Environmental Services Report

(SURFACE WATER DISPOSAL/ TREATMENT DESIGN ONLY)
REQUEST FOR ADDITIONAL INFORMATION
REG. REF. SD21A/0246 (POINT 7 & 9)

For Proposed Residential Development comprising 8 dwellings

Grangebrook Avenue, Rathfarnham, Dublin 16.

SITE: 8 HOUSES AT GRANGEBROOK AVENUE	01 DRAWING NO.	01 PAGE NO.	MAY'22 DATE.	 
	NTS SCALE	DRAWN.	CHECKED.	
TITLE: CROSS SECTION TYPICAL

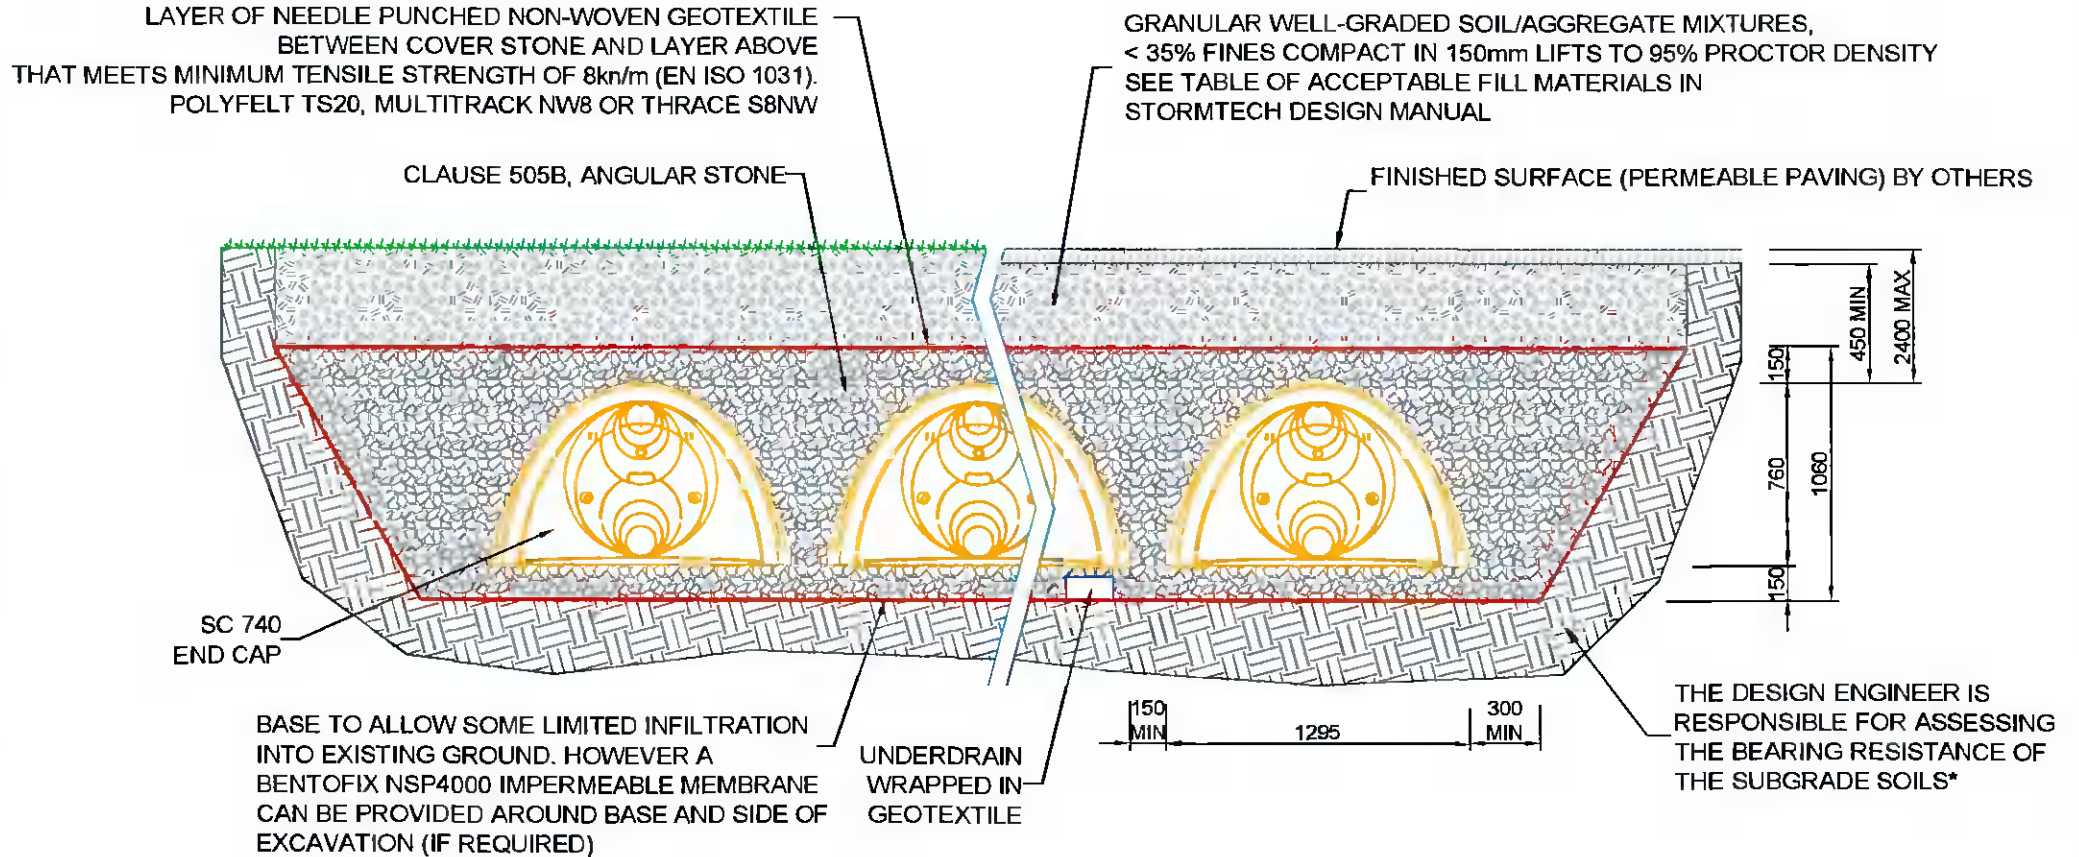
- (a) A report showing site specific soil percolation test results and design calculations for the proposed soakaways in accordance with BRE Digest 365 – Soakaway Design.***
- (b) A revised surface water drainage layout drawing showing plan & cross-sectional views, dimensions, and location of proposed soakaways. Any proposed soakaway shall be located fully within the curtilage of the property and shall be:***
 - i) At least 5m from any building, public sewer, road boundary or structure.***
 - ii) Generally, not within 3m of the boundary of the adjoining property.***
 - iii) Not in such a position that the ground below foundations is likely to be adversely affected.***
 - iv) 10m from any sewage treatment percolation area and from any watercourse / floodplain.***
 - v) Soakaways must include an overflow connection to the surface water drainage network"***

Enclosed in Appendix C are typical longitudinal and cross sections of the Stormtech underground attenuation system. The Stormtech is supplied in modular units which can be configured in alternative layouts i.e. one single line, two/ three lines side by side etc. therefore each site will be subject to a final design confirmation

NOTE:
DUE TO THE LIMITED SITE SIZE & SMALL STORAGE REQUIREMENTS
OF EACH INDIVIDUAL SITE, A SINGLE LINE OF STORMTECH SC740
MAY BE UTILISED. FINAL DESIGN SUBJECT TO SITE INSPECTION
PRIOR TO INSTALLATION OF THE STORAGE SYSTEM.
